6B  
DOE/EIS-0119F

**ADDENDUM  
(FINAL ENVIRONMENTAL IMPACT STATEMENT)**

**Decommissioning of Eight  
Surplus Production Reactors  
at the Hanford Site,  
Richland, Washington**

**December 1992**

Figure 3-27. Flooded area for the probable maximum flood (after ERDA, 1976).

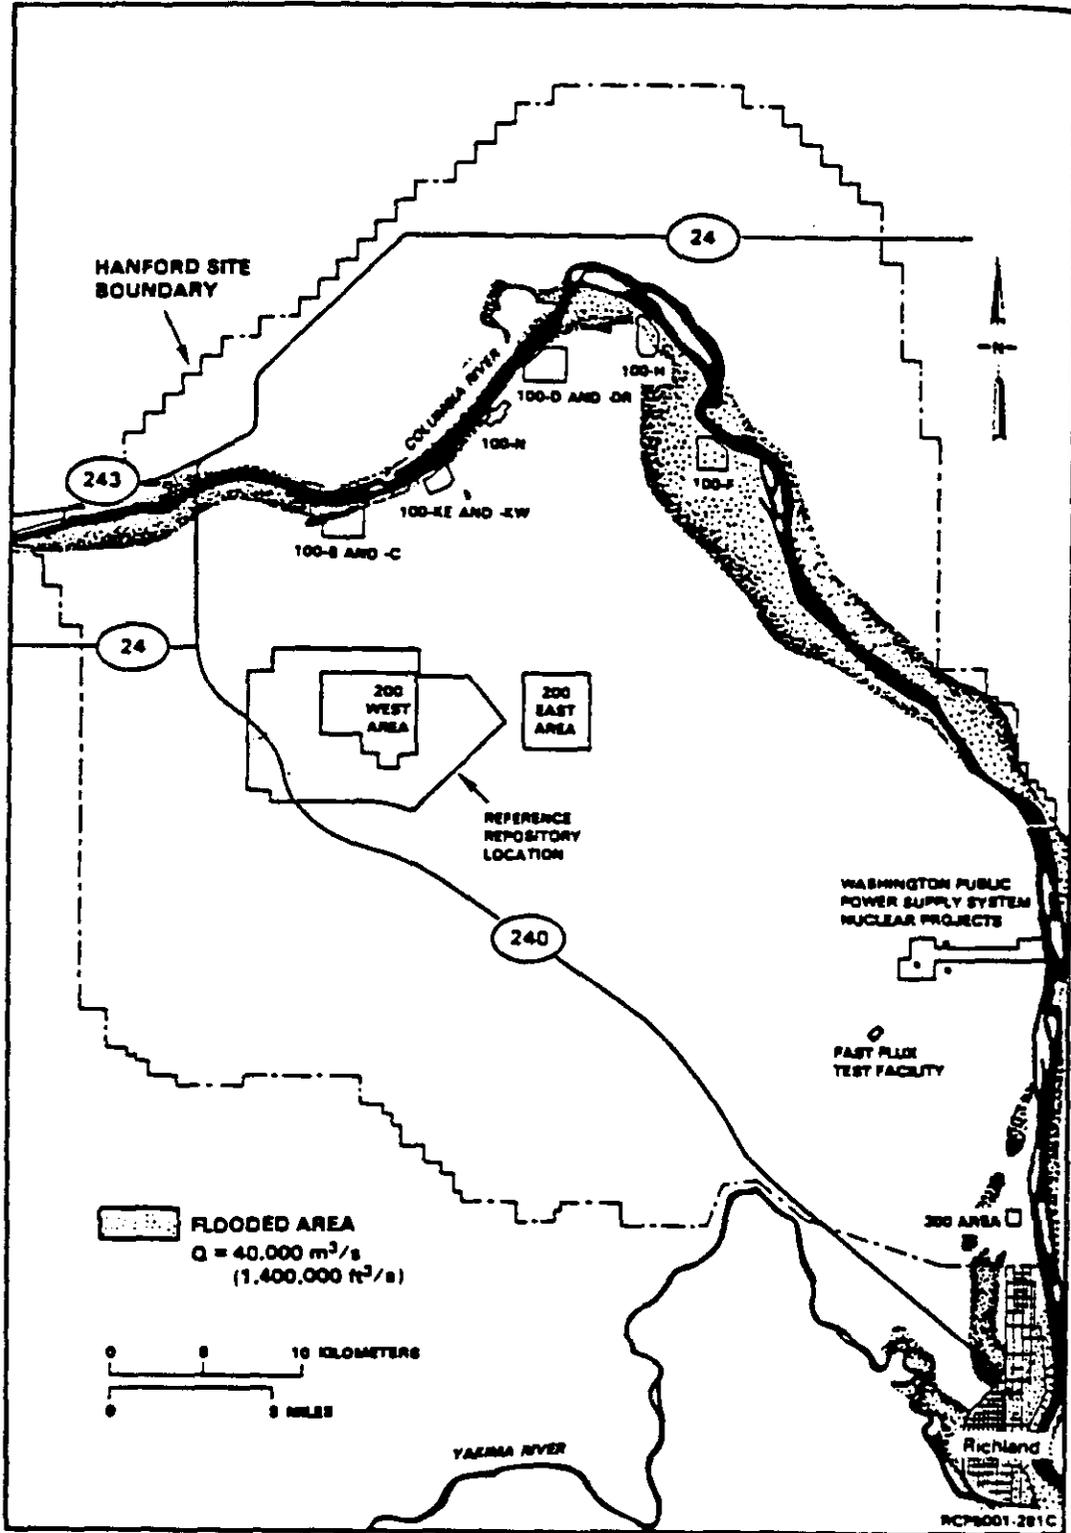
**L042-C08.** Columbia River flow alteration could be caused by factors in addition to climatic changes (page 3.57). The FEIS should describe erosion and accretion processes that could change the river channel and lead to immersion of the reactors.
